ADDENDUM NO. SIX TO THE CONSTRUCTION DOCUMENTS FOR:

PROJECT: Cypress River Lofts, 1381, 1382, 1385, & 1389 Duane Street,
Baton Rouge, LA 70802

NUMBER: 75-01-17

DATE: March 3, 2023

MAP SHOWING
 BOUNDARY & TOPOGRAPHIC
 SURVEY OF
**LOTS 11-A & 9-A
 BLOCK 280**
 AND
**PORTION OF LOTS 5,
 6, & 7 BLOCK 281**
 LOCATED IN
 SECTION 51, T7S-R1E,
 GREENSBURG LAND DISTRICT,
 EAST BATON ROUGE PARISH,
 STATE OF LOUISIANA,
 FOR
PARTNERS-FOR-PROGRESS, INC.

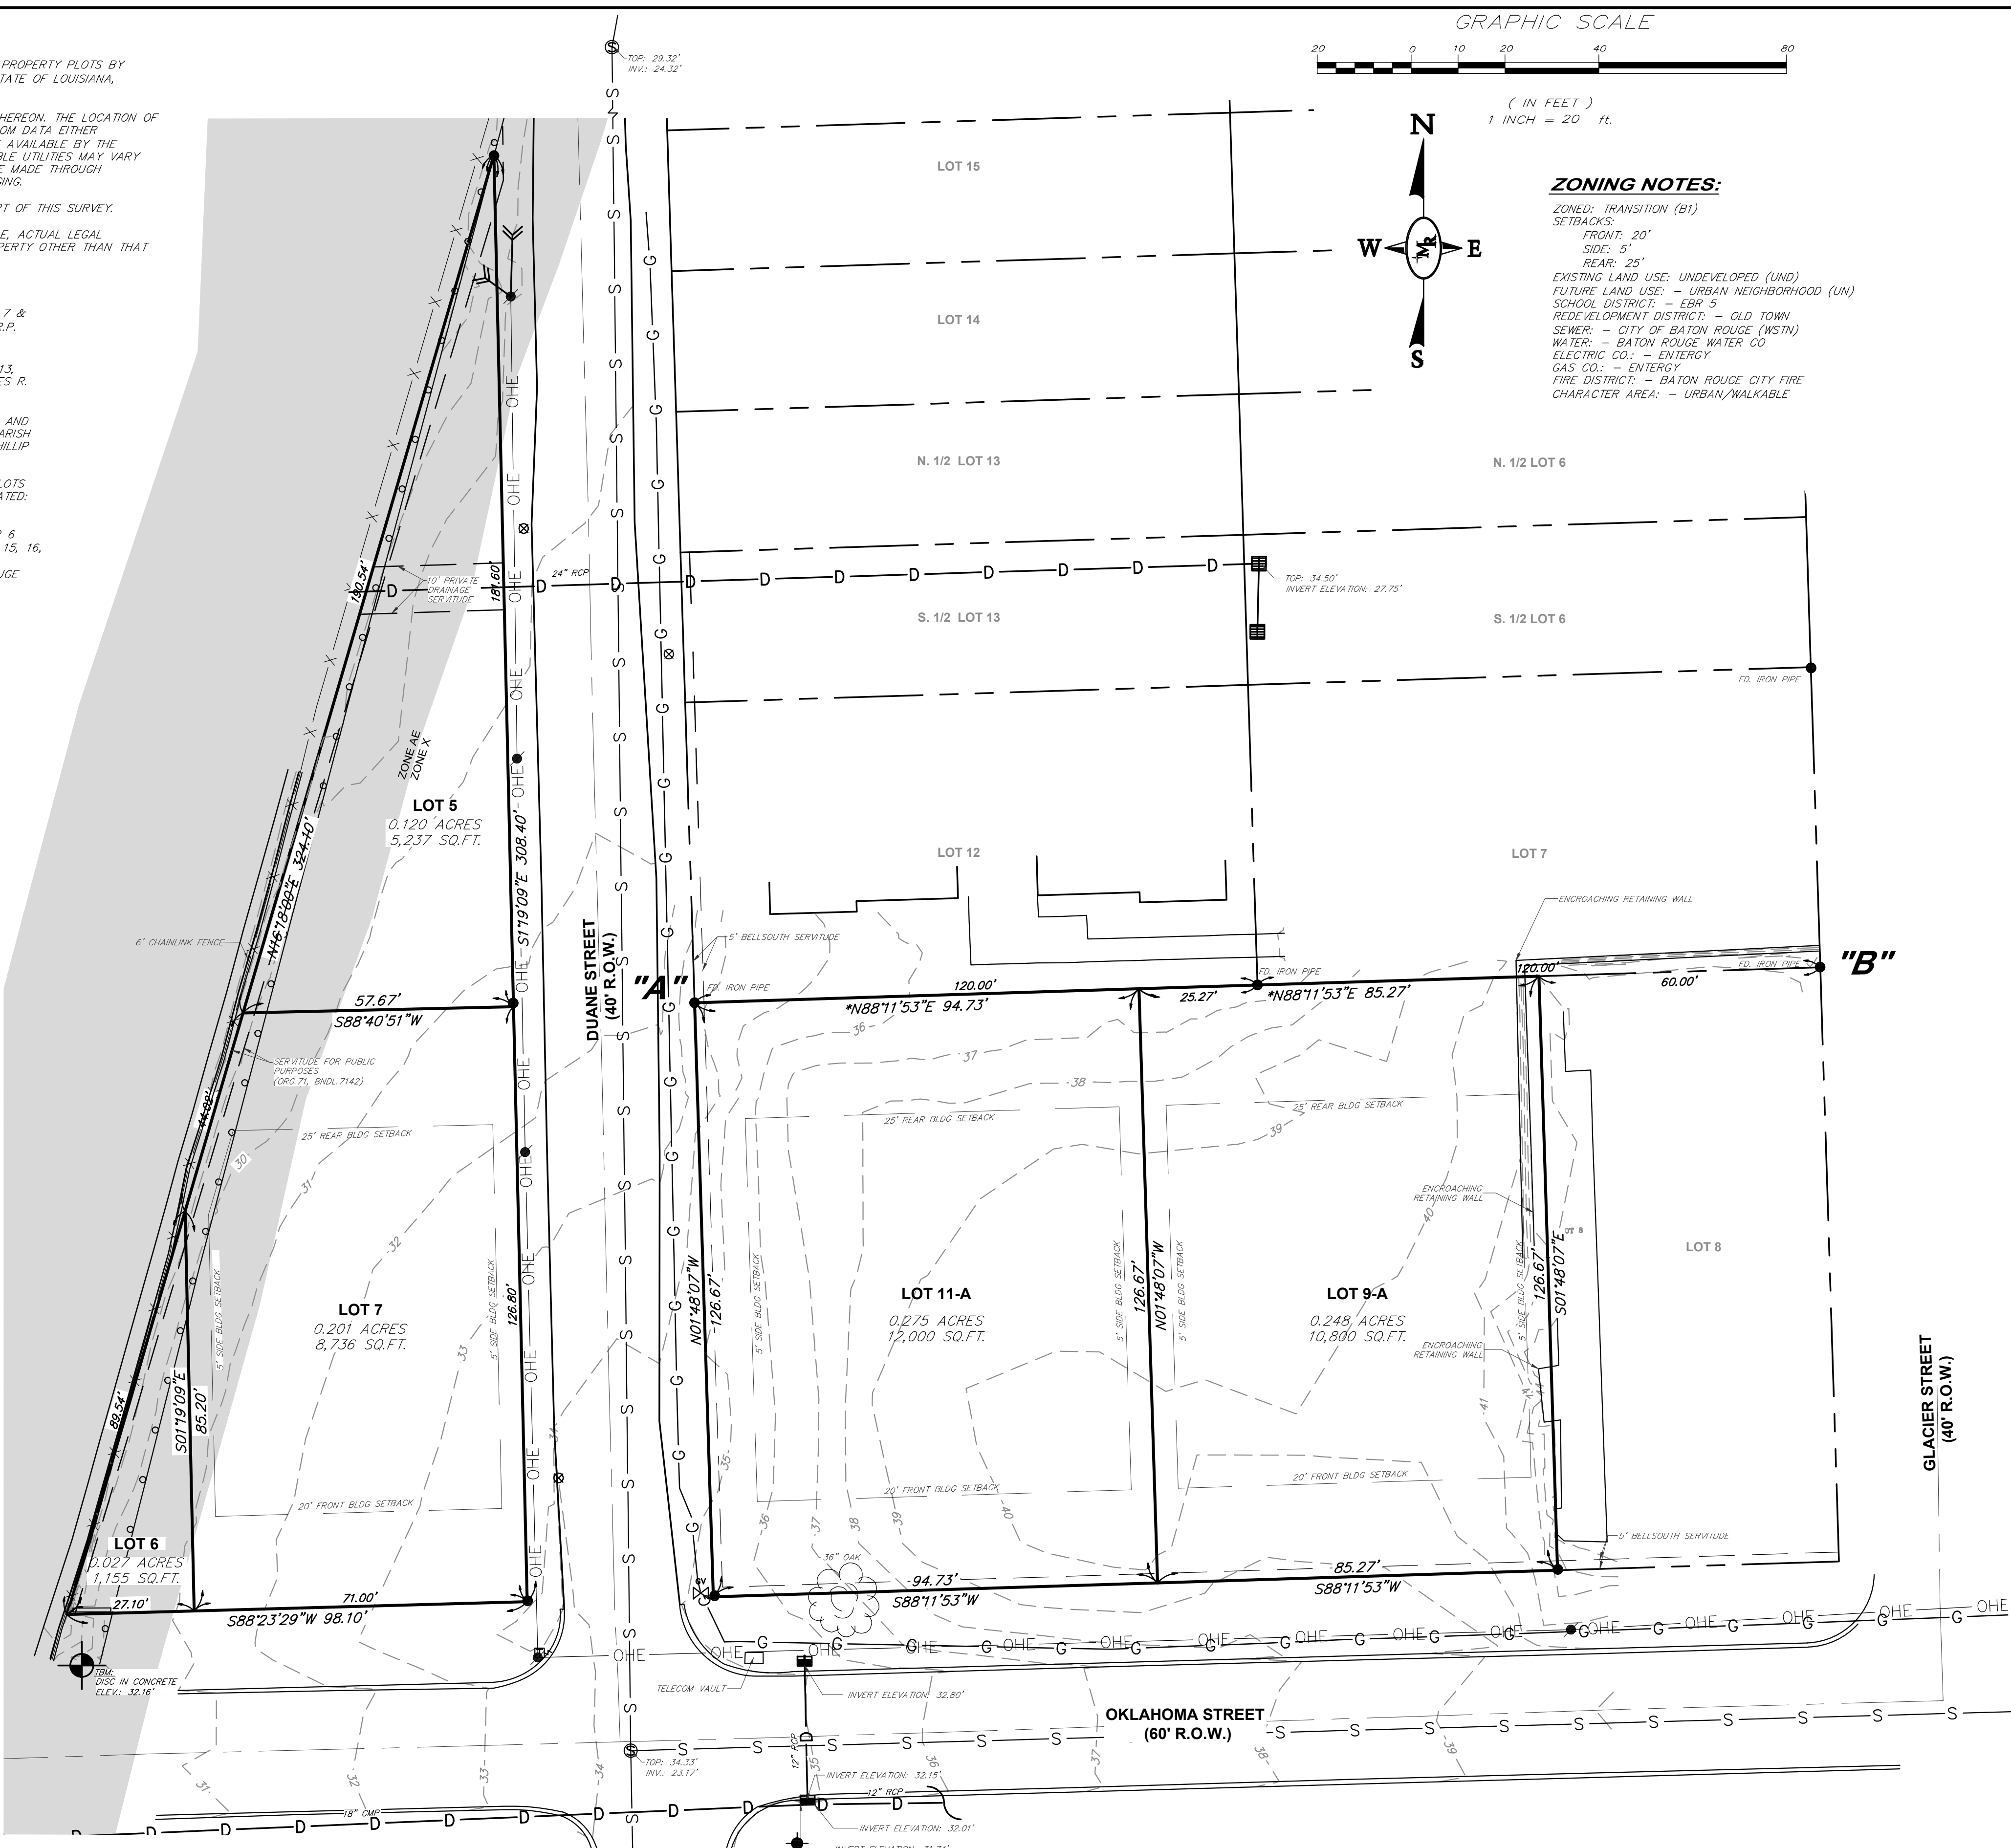
1. Survey: Delete and replace with the attached dated 2-13-2022.

GRADING & DRAINAGE PLAN

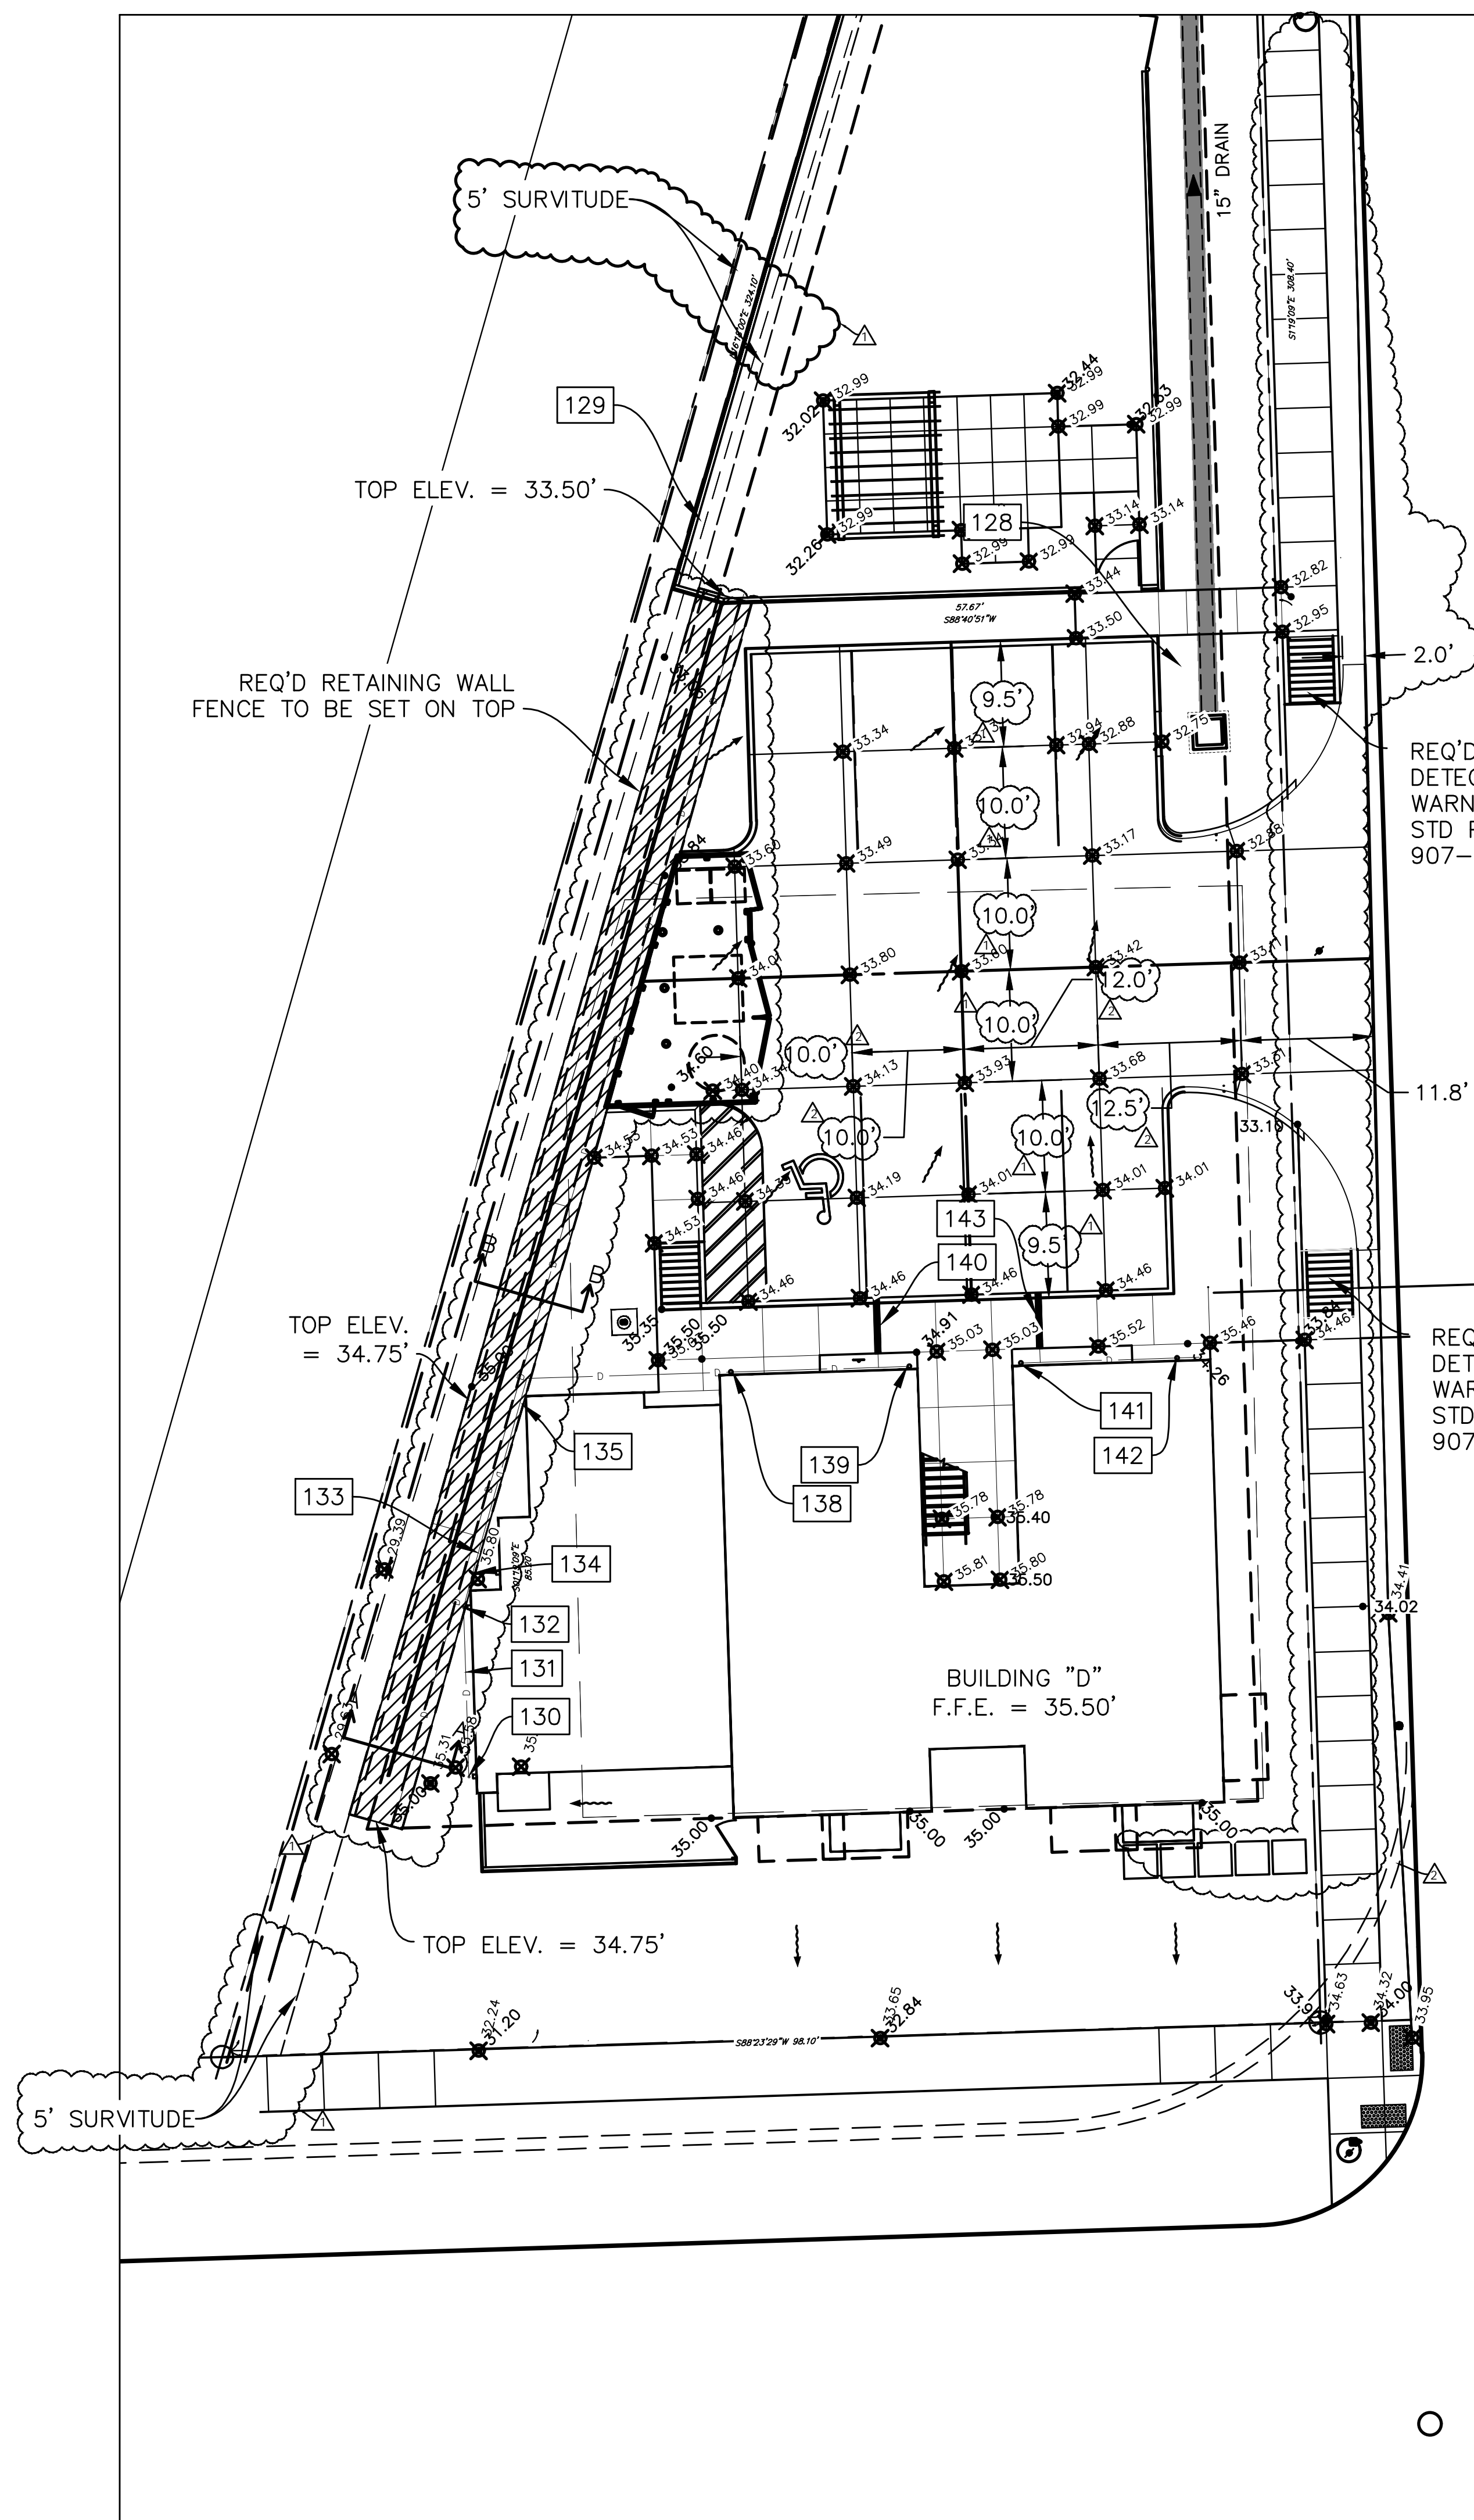
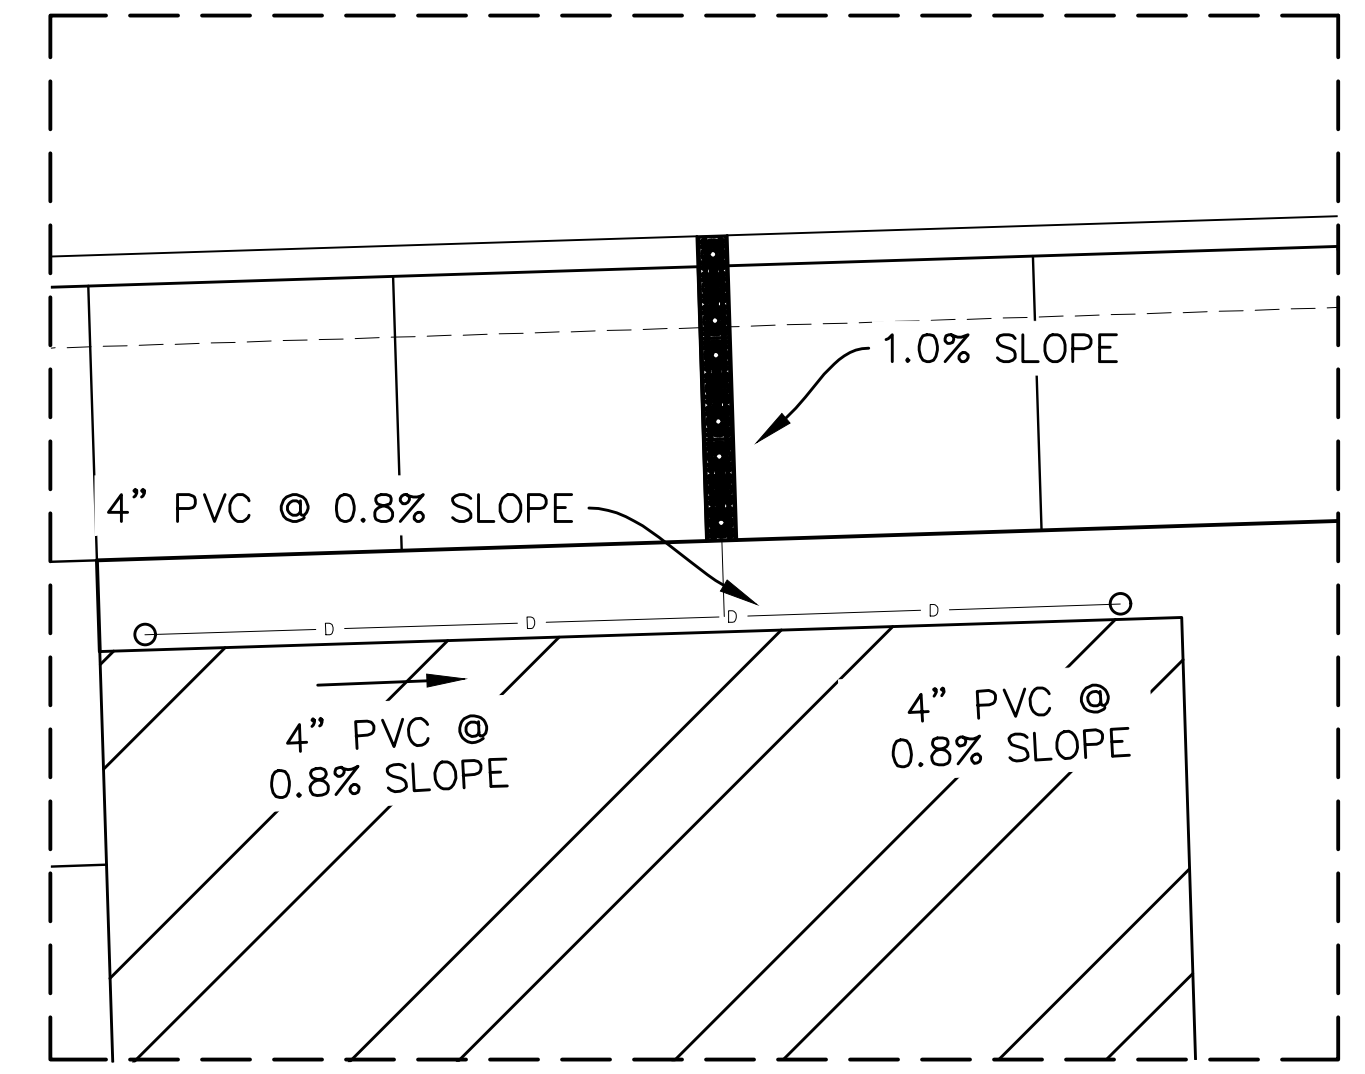
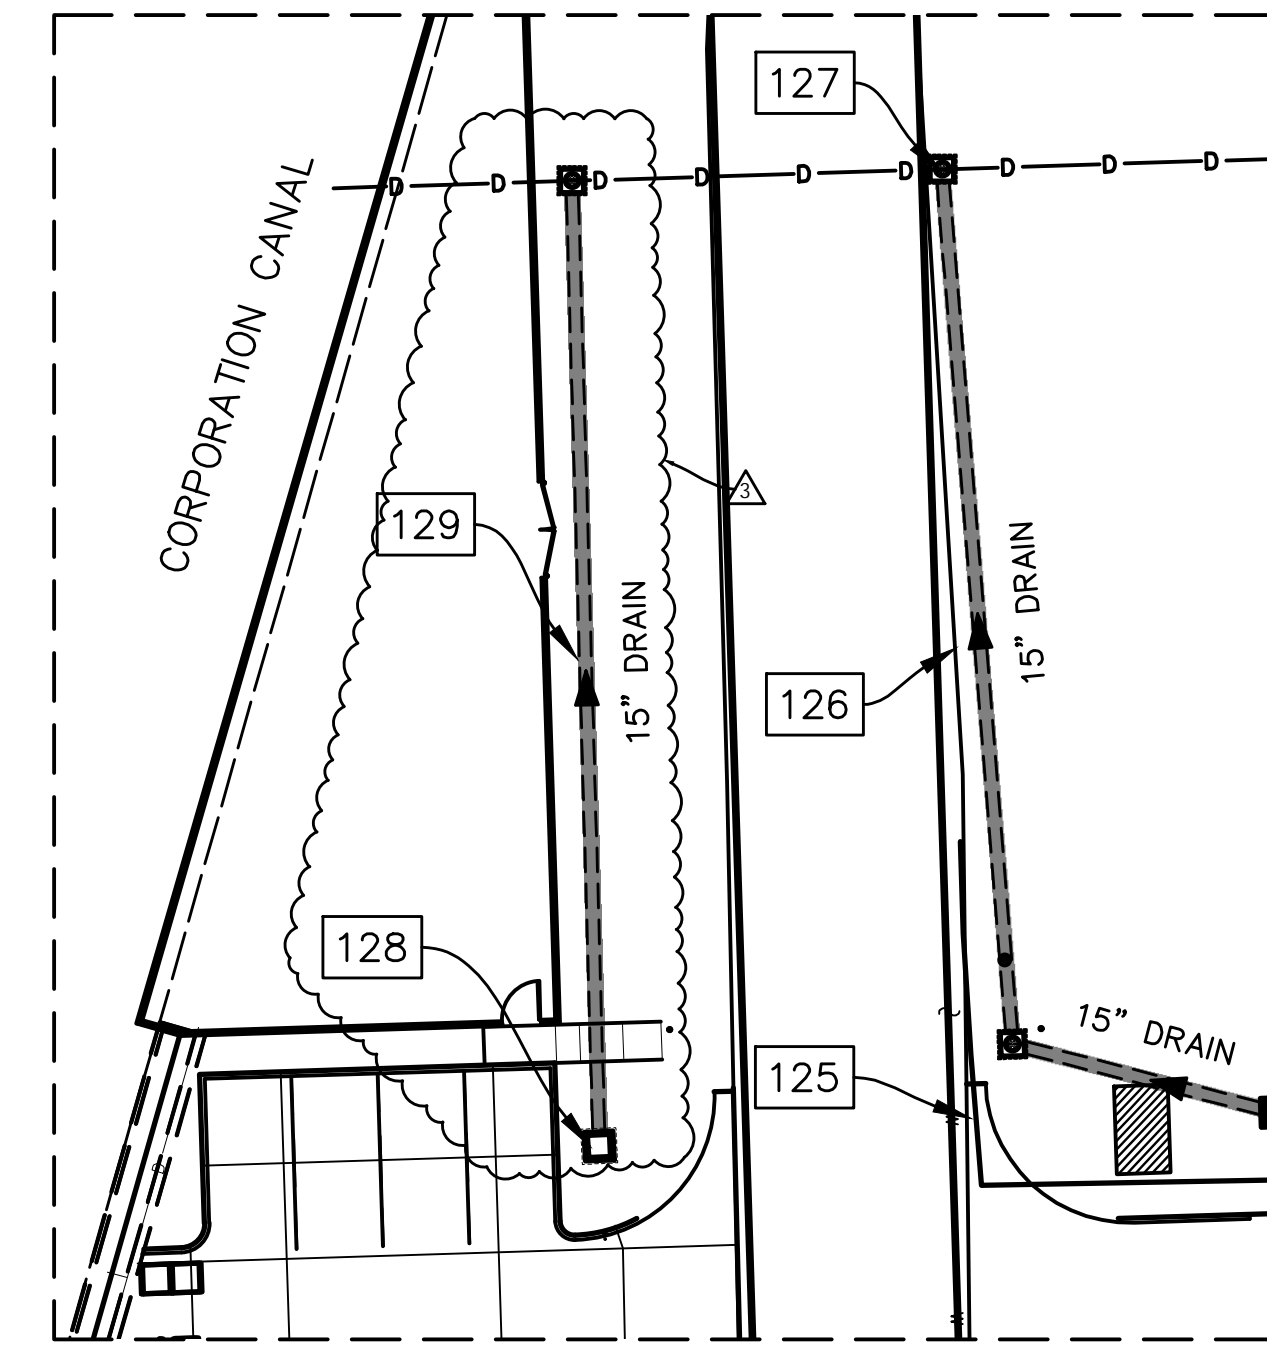
1. Sheet C2.01: Delete and replace with the attached.
